NONCONFORMANCE REPORT

16 NCR NO. C-01006

Watertight doors & frames

Contract A17AQ Julius Mock & Sons, Inc.
 Watertight doors & frames

Door 32 (C)

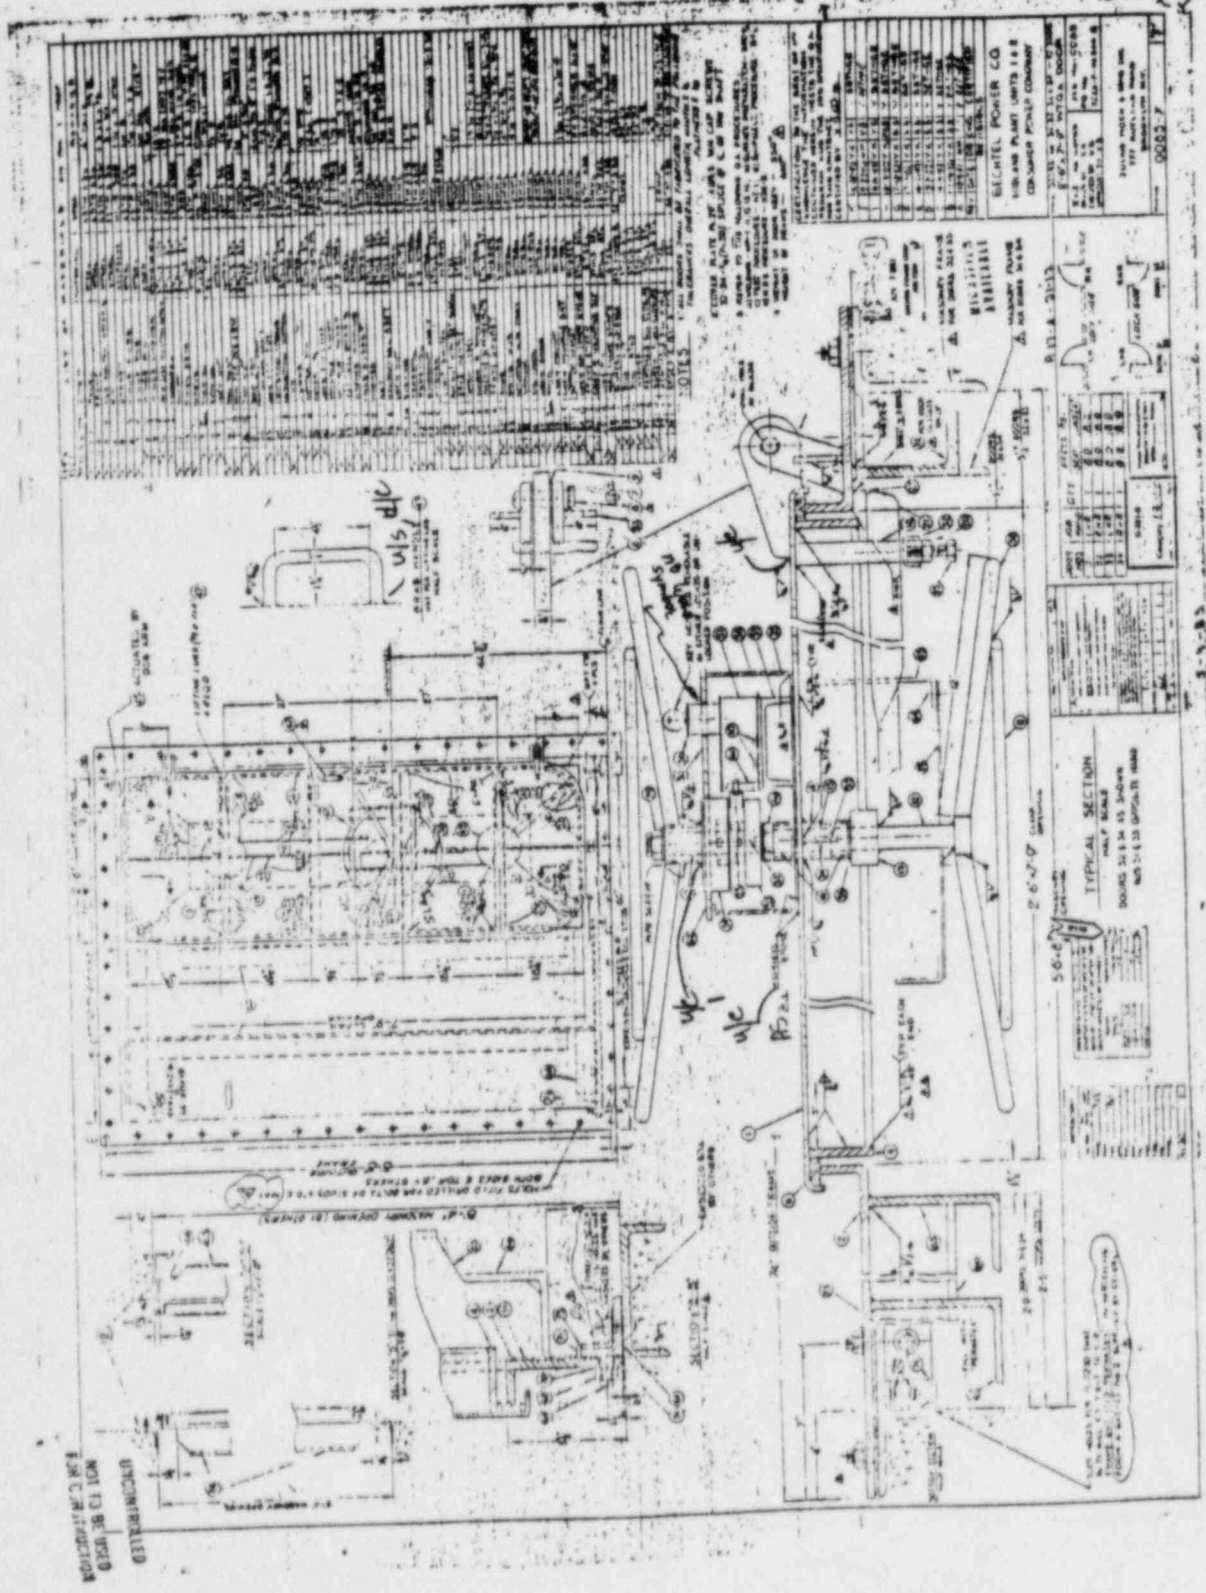
w/c - window
A/S - arc strike
w/s - window size

Door #34 (1)

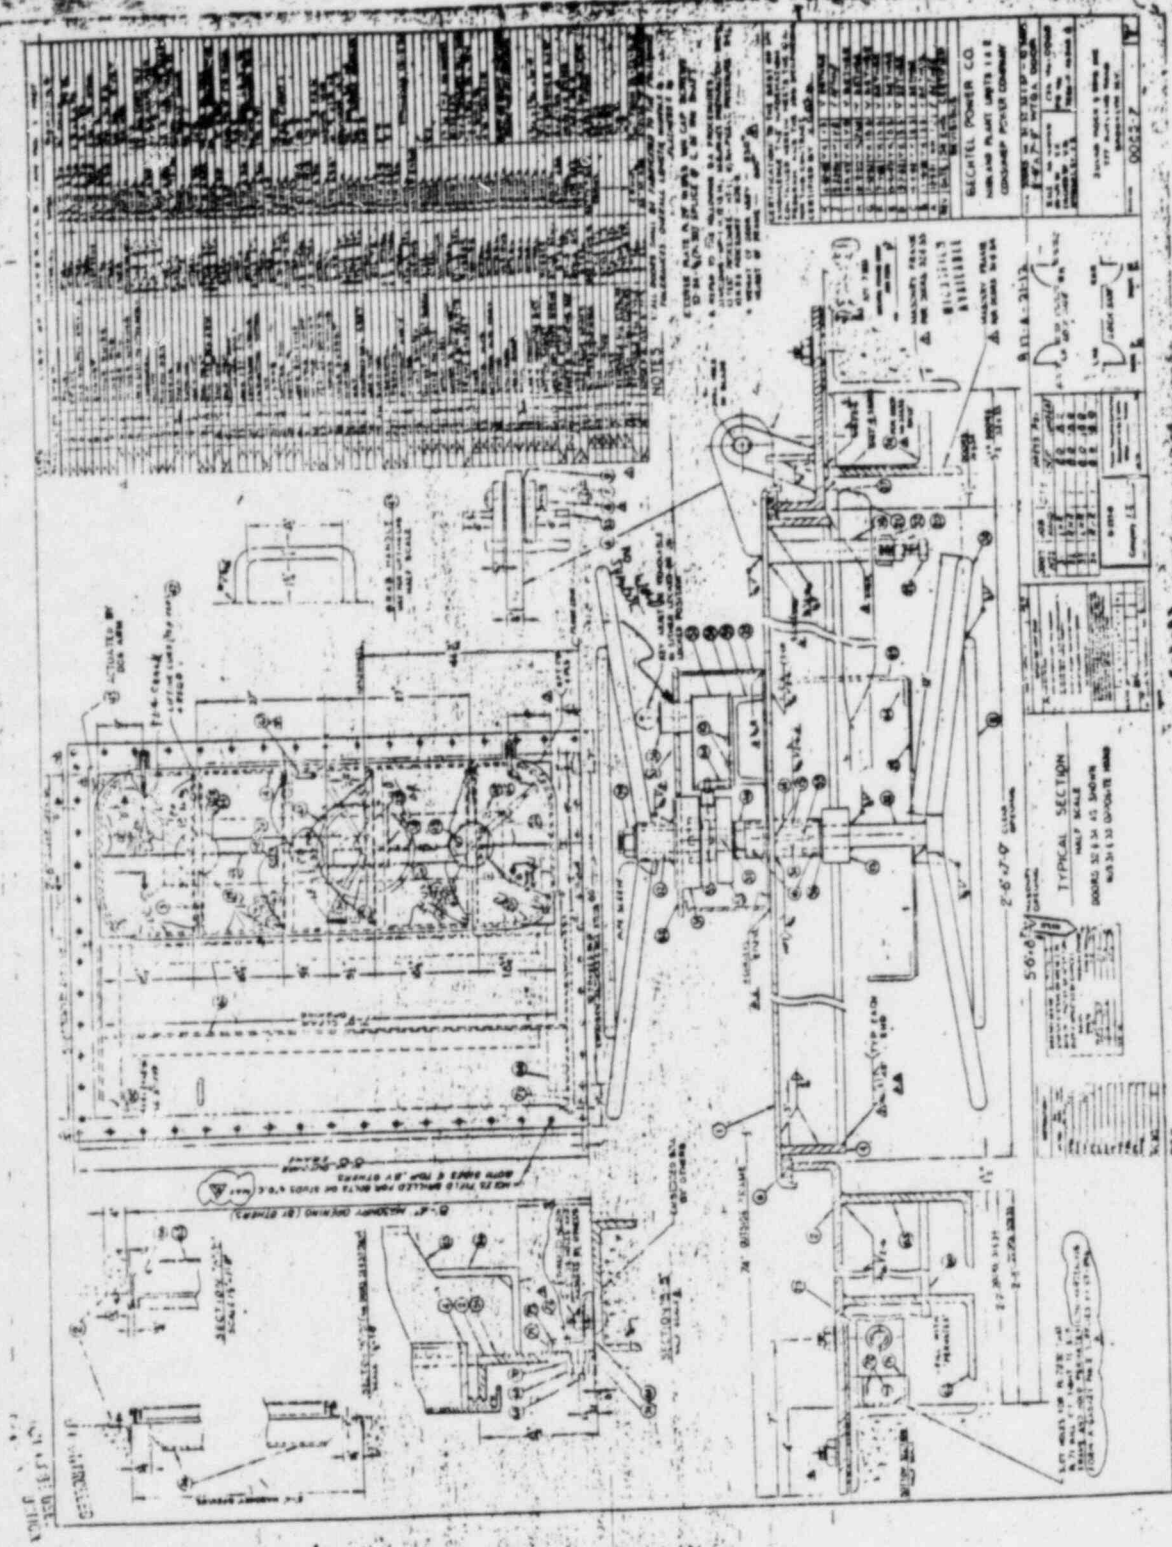
u/c = undercut
 P.O. = POROSITY
 C.R. = COLD ROLL / LAP
 L.F. = LACK OF FUSION

Door # 40 ©

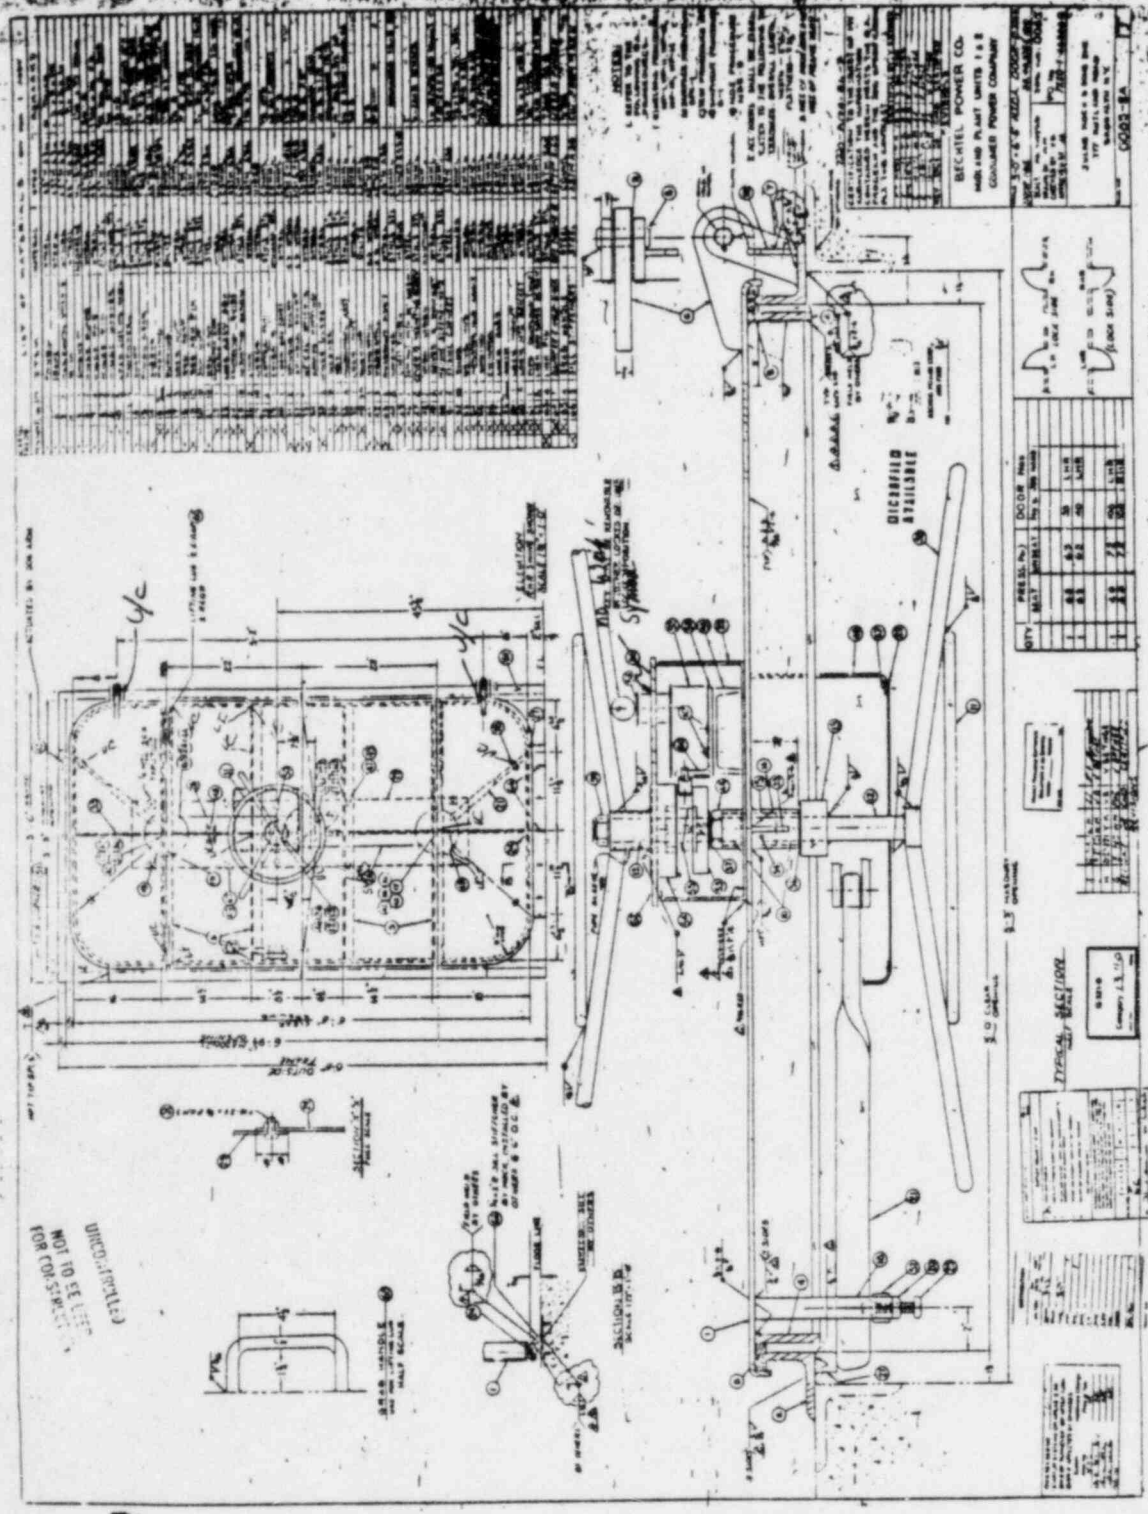
4/c = undercut
 4/s = under-scribe
 L/F = lack of fusion

Door # 18 @

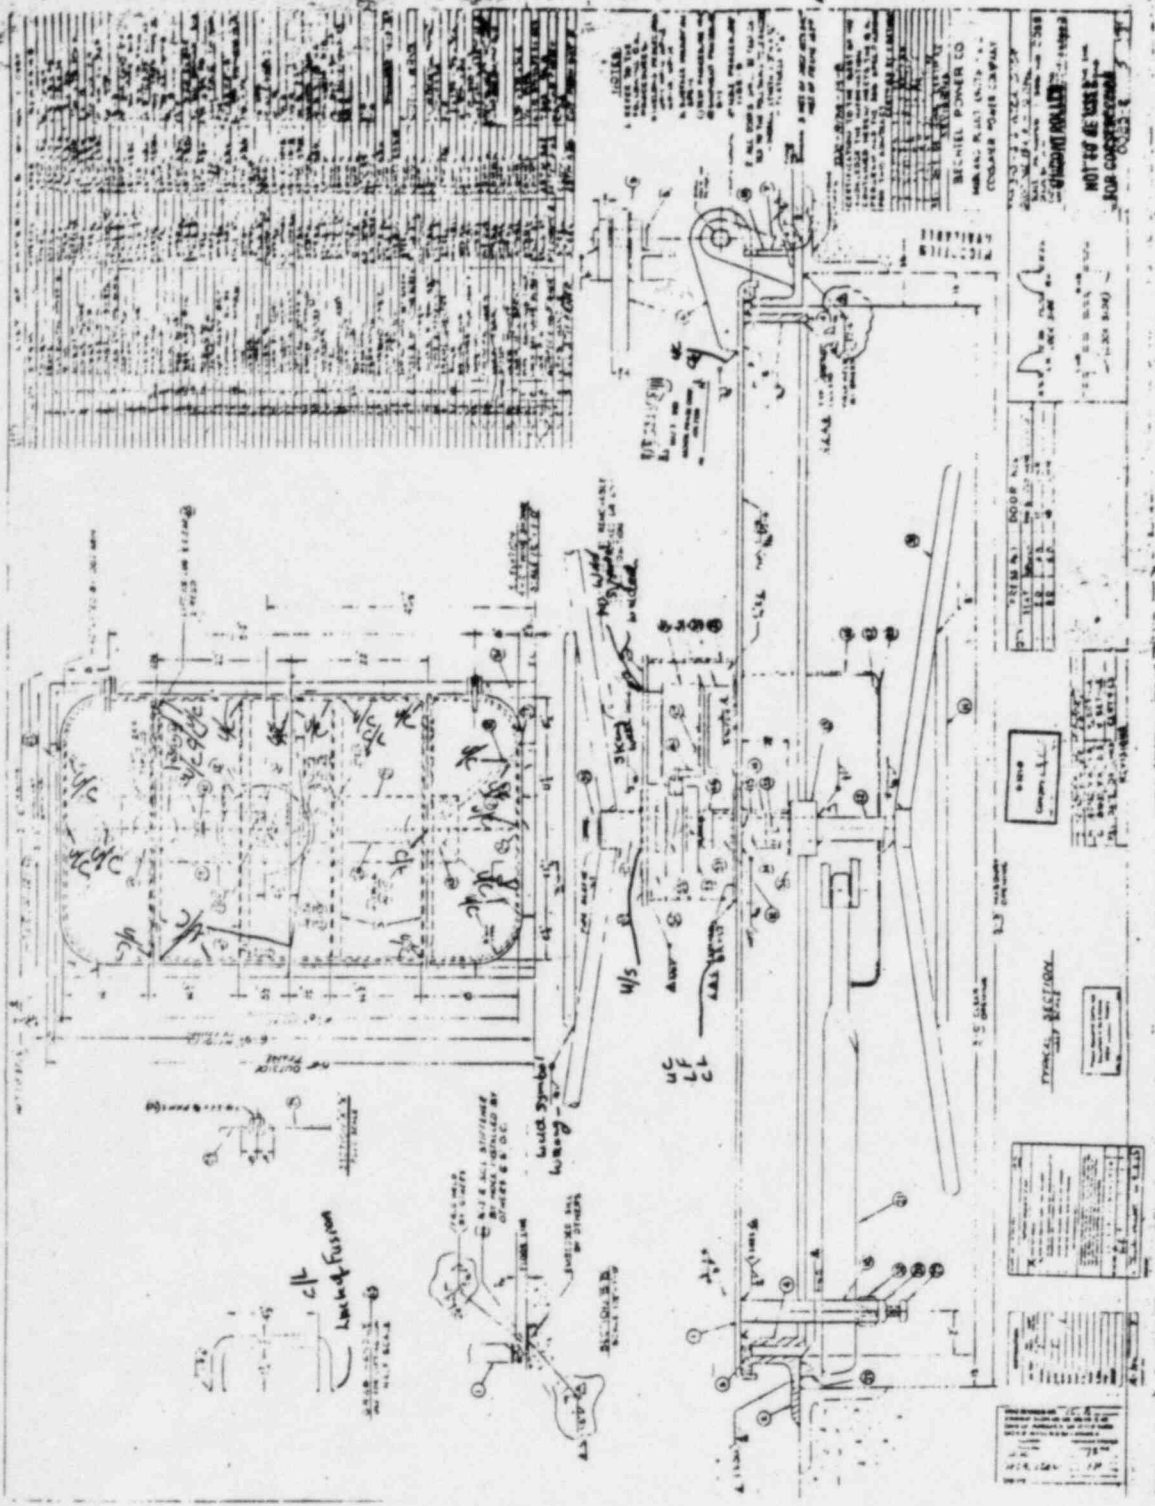
W/L = Undercut
 L/F = Leaf of Fusion
 C/L = Cold Lay/roll

Door # 35 (C)

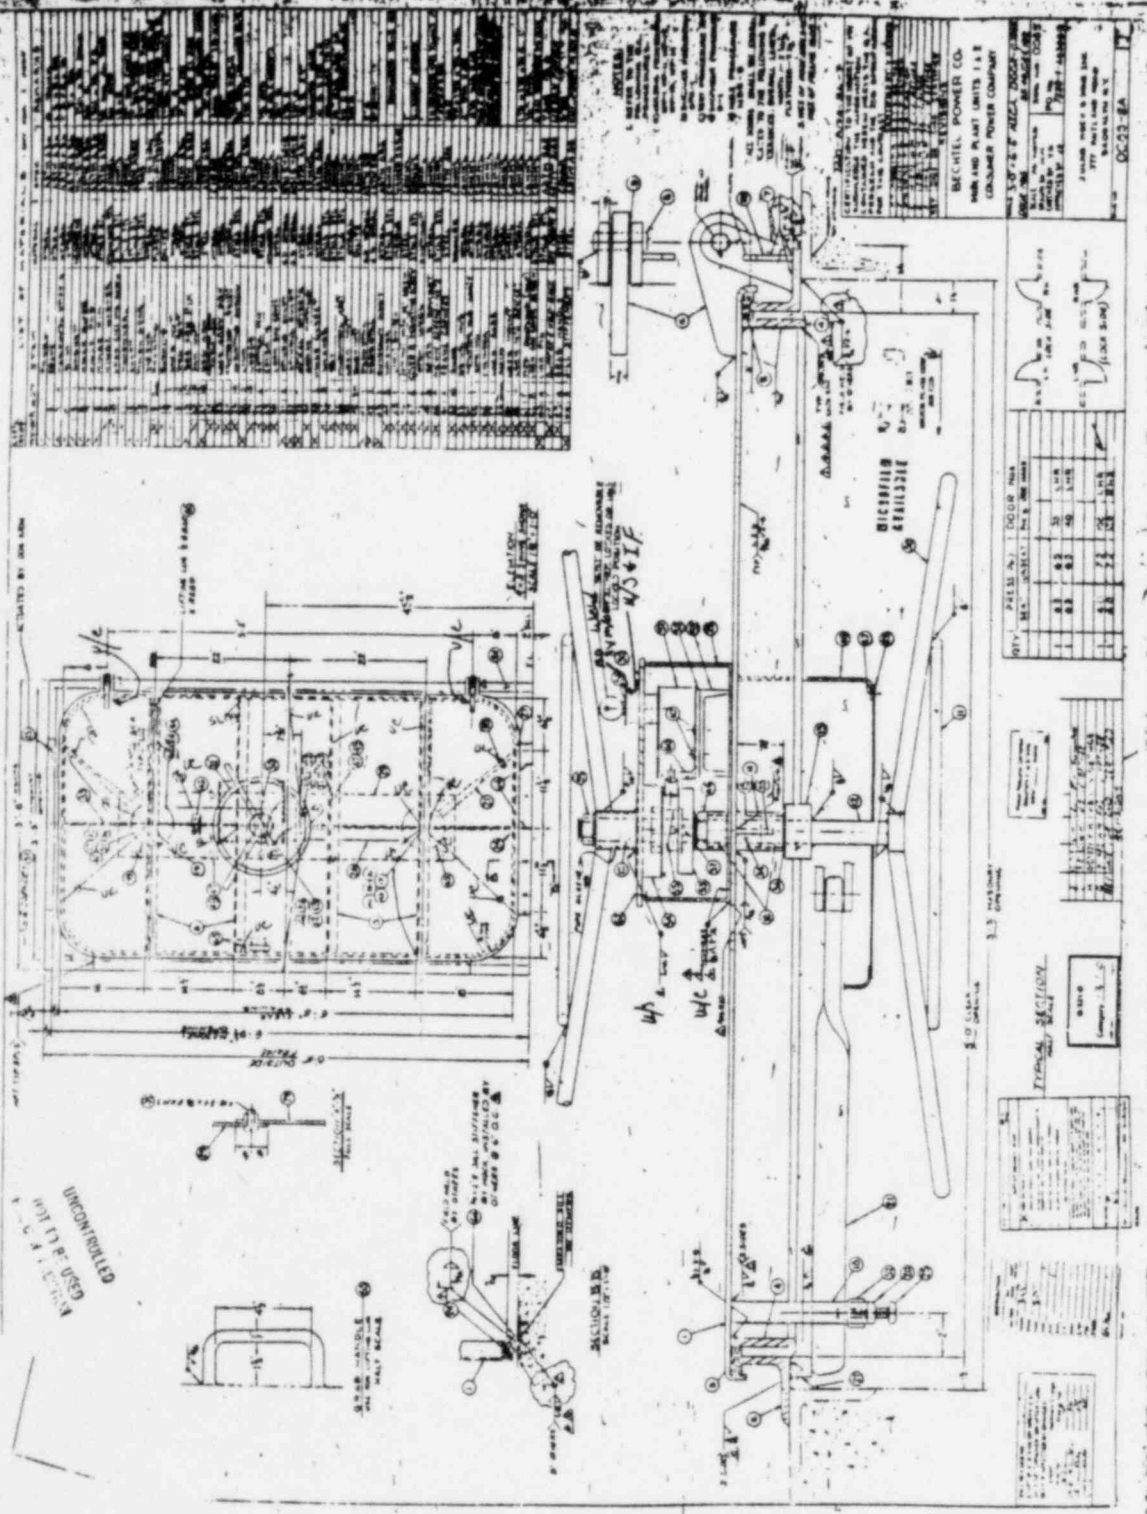
43 = undercut
 45 = undersize
 46 = incomplete fusion

Door #6

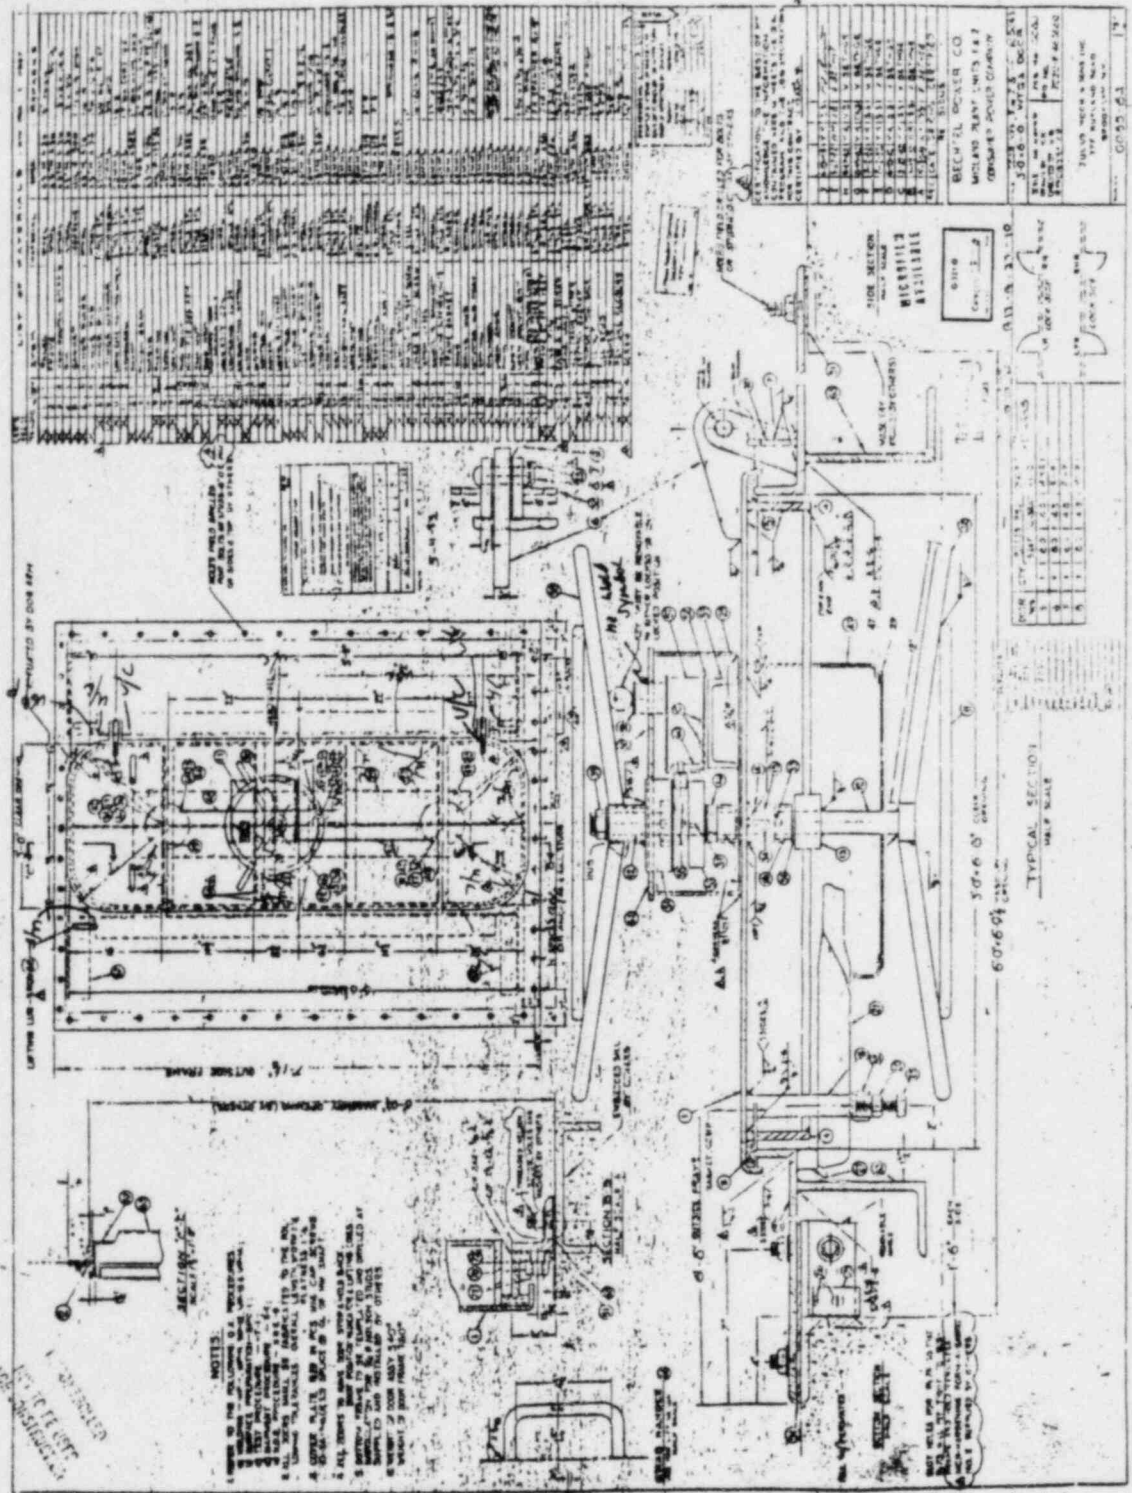
w/c = undercut
L/F = Lock Fusion
